PLAN 2

PLANNING APPLICATION PLN-19-0131

42 MARLBOROUGH STREET, LONGFORD

**Additional Information Required for Planning Application PLN-19-0131- Dwelling (heritage precinct) at 42 Marlborough Street, Longford**

**The Lower Roof**

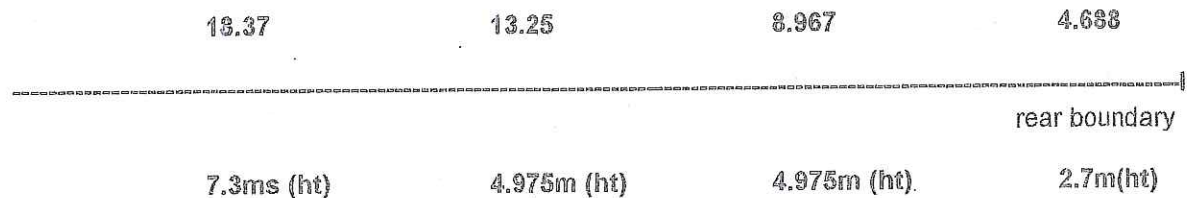
- a) The first rise of roof pitch, the lower roofline, occurs at **4.688ms** from the rear boundary fence (see site plan).
- b) At that point the exterior wall of the family room is at 2.7 ms measured from floor level to ceiling.
- c) The roof then rises at 28° above the Family Room and Bed 3 to its peak, a point in line with the stacker door of the alfresco area (best seen on the Floor Plan). That peak occurs at approximately **8.967ms** from the rear boundary (3.267ms + 5.7ms); the gradient having commenced 4.688ms from the rear boundary.
- d) The 28° rise occurs over a distance of 4.279ms (8.967ms – 4.688ms). Using **Tangent 28° = 0.531709** produces a vertical roof rise of 2.275ms above the 2.7ms wall height (total **4.975ms** above natural ground at 8.967ms from the rear boundary).

Photo 1

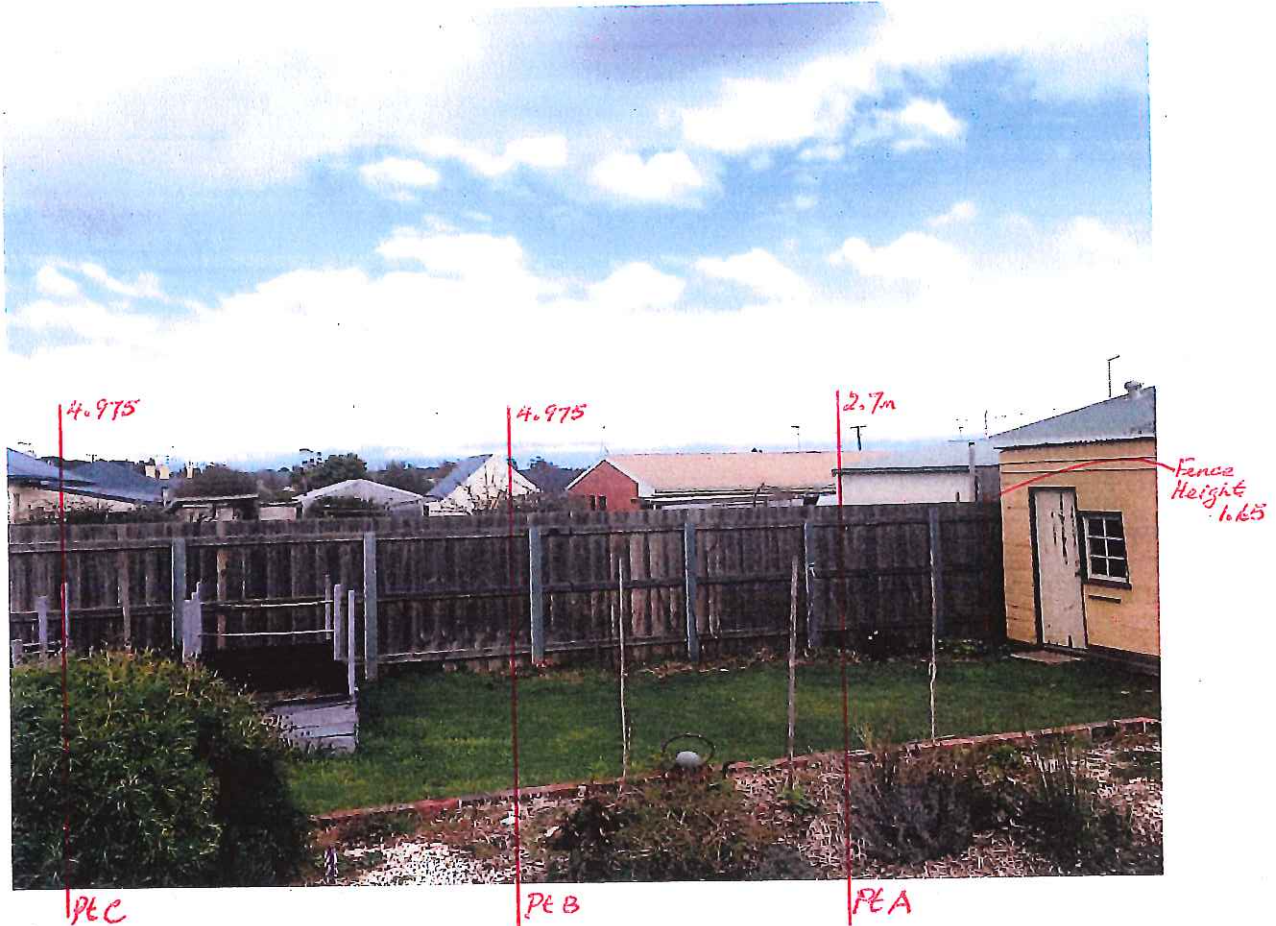
Marked in red are the points on the boundary fence at which the proposed dwelling will rise. All depictions are in accordance with the calculations made in Attachment D. *The marked heights are not to scale.*

Fence height is approximately 1.65ms in height above Natural Ground, with small variations to 1.77ms.

**ELEVATIONS**  
 SCALE: 1:100

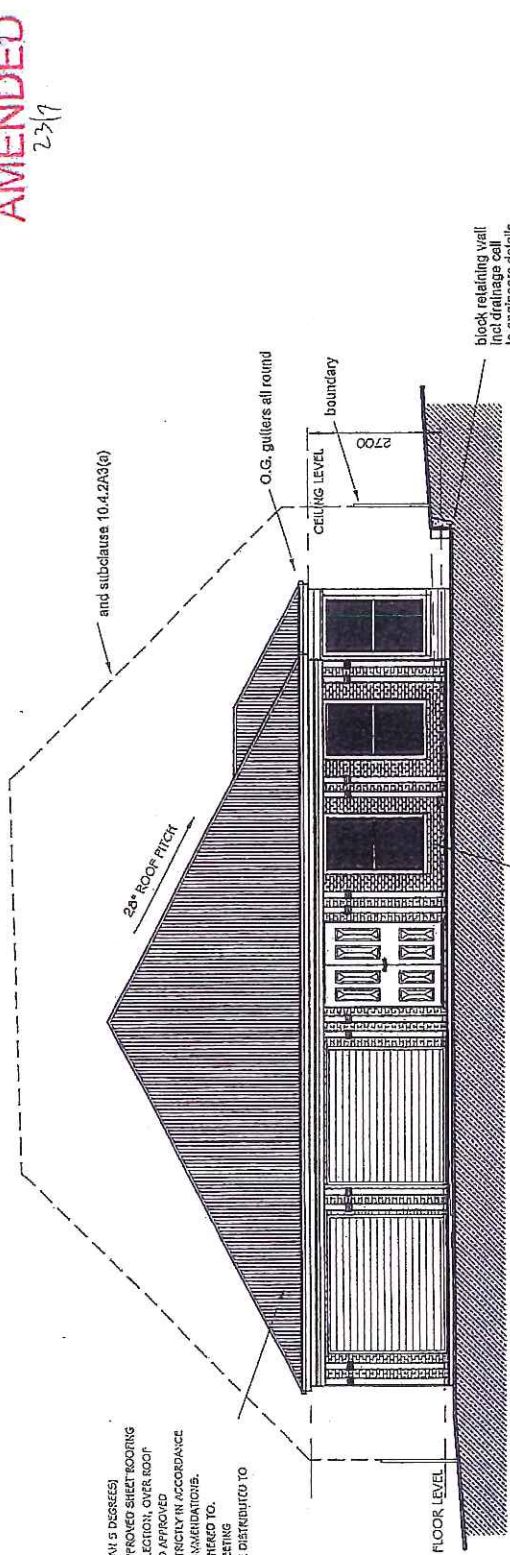
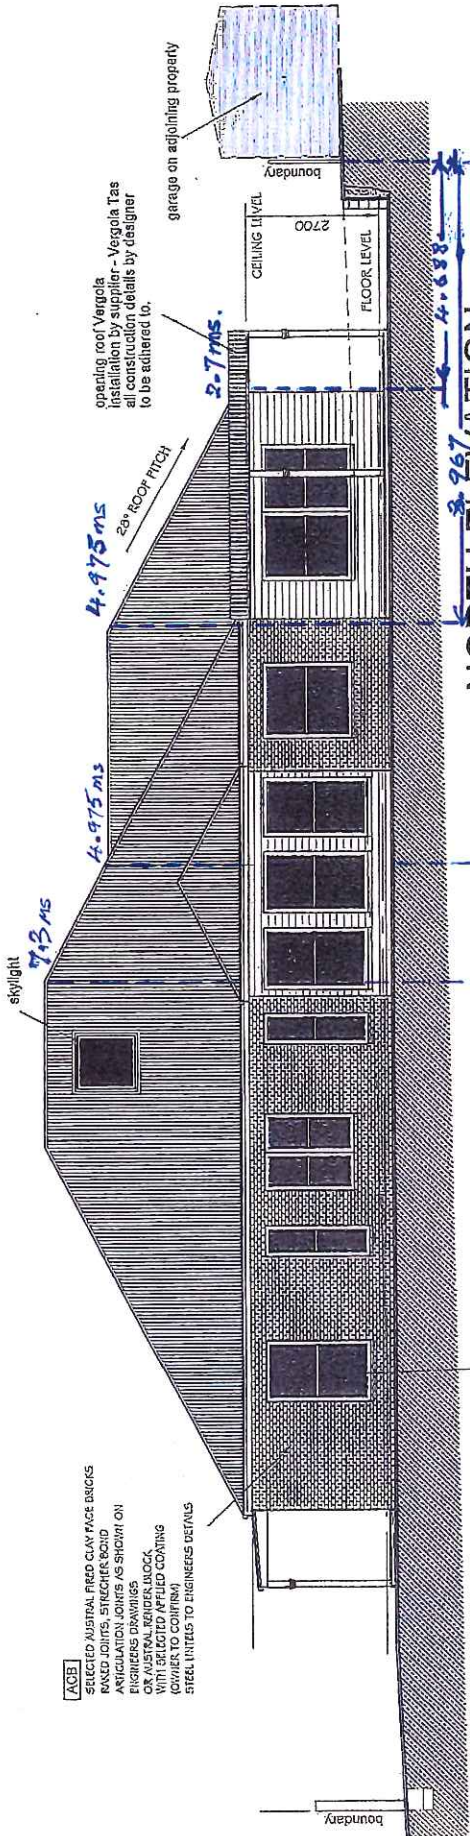
- The Elevation drawings for the West and South are not in accordance with the amended plans. They do not illustrate the amended roofline at the rear of the dwelling; and do not provide accurate depiction of the outline of the building.

- a) the exterior wall of the family room is 2.7ms in height, at 4.688ms from the rear boundary fence (see Site Plan)
- b) The first rise of roof pitch being the lower roofline (right hand side of the North Elevation), occurs at that point (see also Site Plan); and reaches its apex of 4.975ms above natural ground at a point 8.967ms from the rear boundary
- c) The second rise in roof pitch seen on the diagram concerns the main (higher) roofline. The rise commences from wall height at the 8.967ms point and visually intersects the profile of the lower roof at its height of 4.975ms at a point 13.25ms from the rear boundary.
- d) It rises from this intersection point to its apex of 7.3ms (see South Elevation), which occurs at about 17.43ms from the rear boundary
